CITY OF ALBANY  
Public Works Department

ADDENDUM NO. 1

ST-18-02,  
SANTA MARIA AVENUE IMPROVEMENTS

**MULTI/TECH**  
ENGINEERING SERVICES, INC.  
1155 13th ST. S.E. SALEM, OR. 97302  
PH. (503) 363-9227 FAX (503) 364-1260  
www.multitech.ws office@multitech.ws

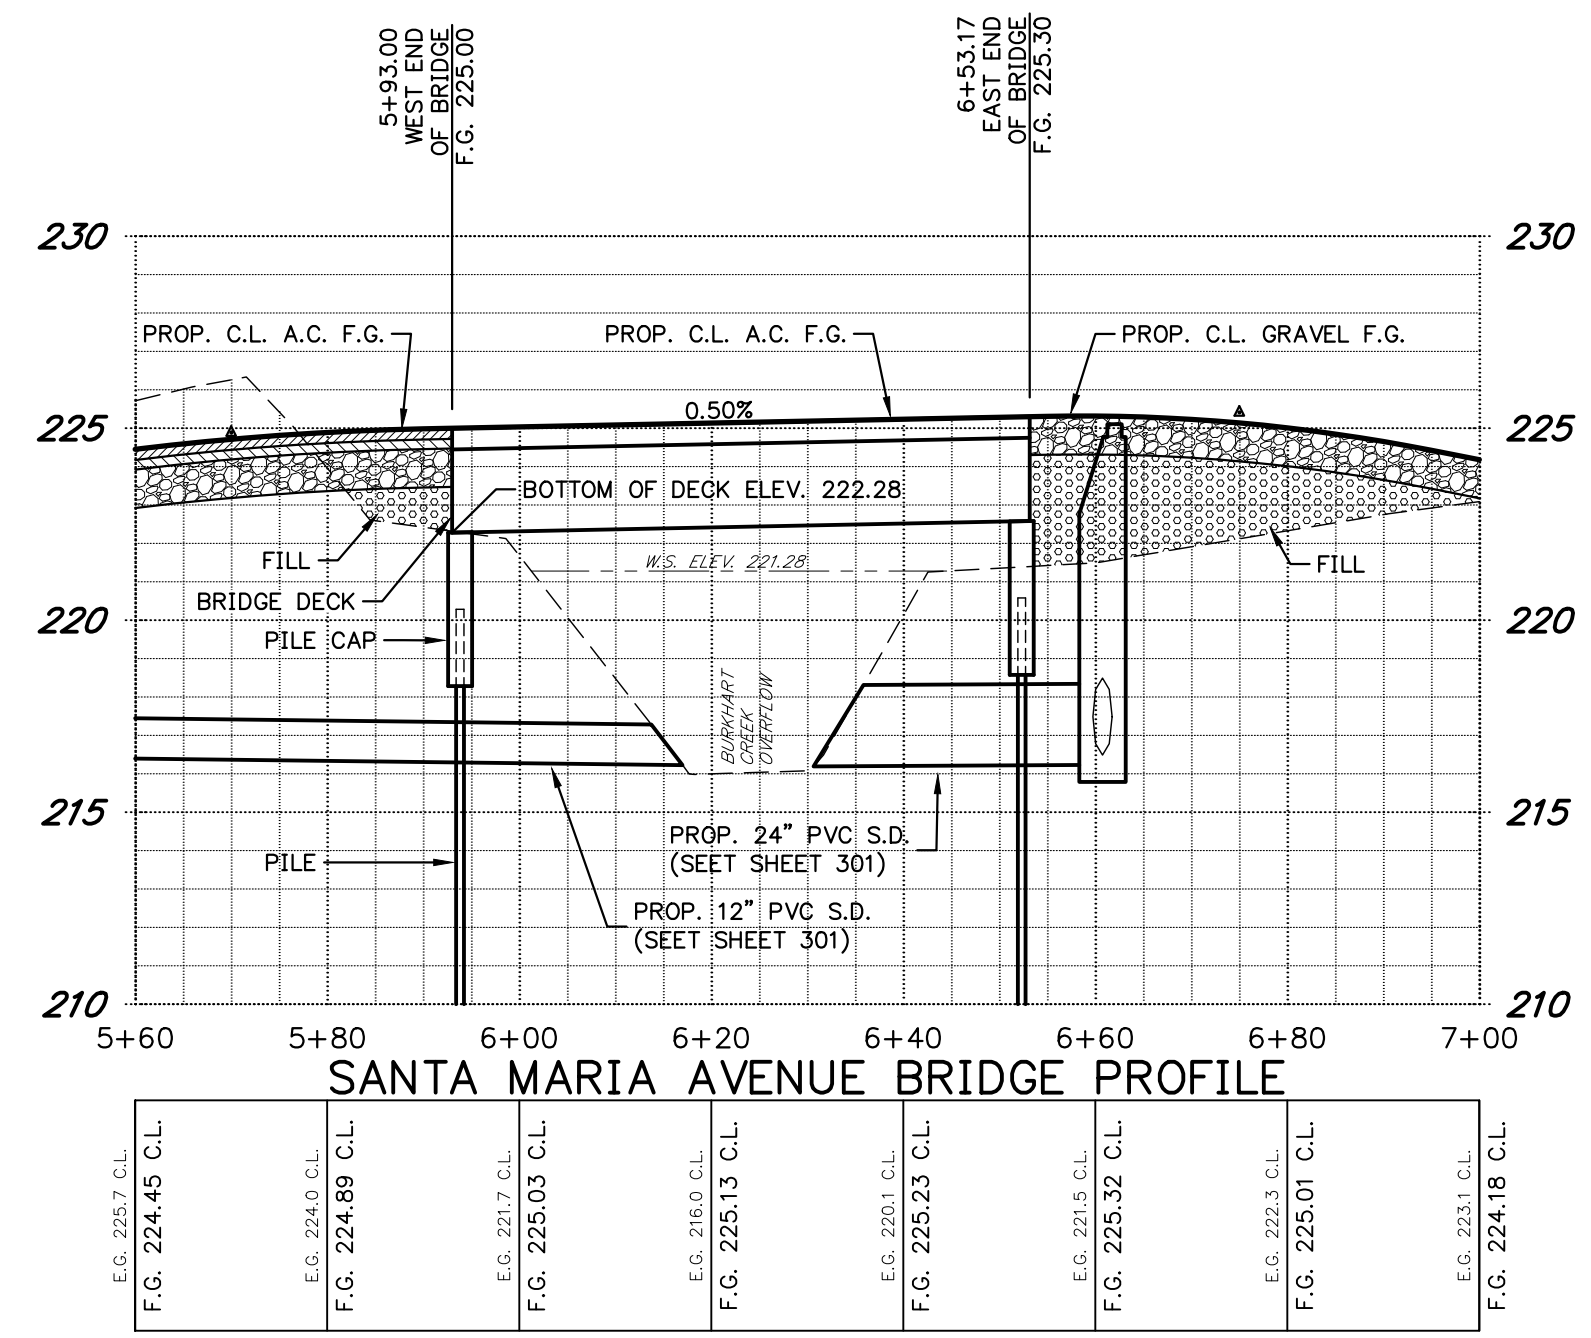
Replace existing Sheet No. 402 with the new updated version of Sheet No. 402. The new drawing updates the note for the pedestrian handrail to include a reference to ODOT Standard Drawing BR246.
